Work Order ID 120401

Item ID: D3257-1 Accept *N900040100* Setup Start *NS1*
Revision ID: Stop *NS2*
Item Name: Fitting
Start Date: 6/04/14 Start Qty: 4.00 *4* Cust Item ID:
Required Date: 6/04/14 Req'd Qty: 4.00 *4* Customer:
Reference:

WORK ORDER NON-CONFORMANCE / UPDATE

B D3257-1 FITTING

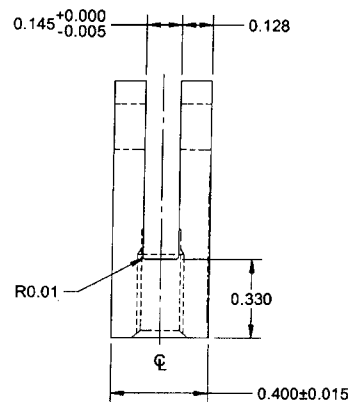
Root Cause	Date	Step	Qty	Description of work order update or non-conformance	Initial Chief Eng	Action Description	Sign & Date	Verification	QC Inspector
Design									
Doc/Data									
Equip/Tooling									
Handling/Pre	14/07/09								
Material									
Operator	☒	110	(8)	Slot .145 $\pm$ 0.005 is off tolerance	S	Scrap + Dism			
Offset/Setup	☒			RC - Tool not well mounted	052002 15/01/23	Replace	14/07/09	15/01/23	15/01/23
Process						M 127947			
Supplier									
Training									
Transport									
Unapproved
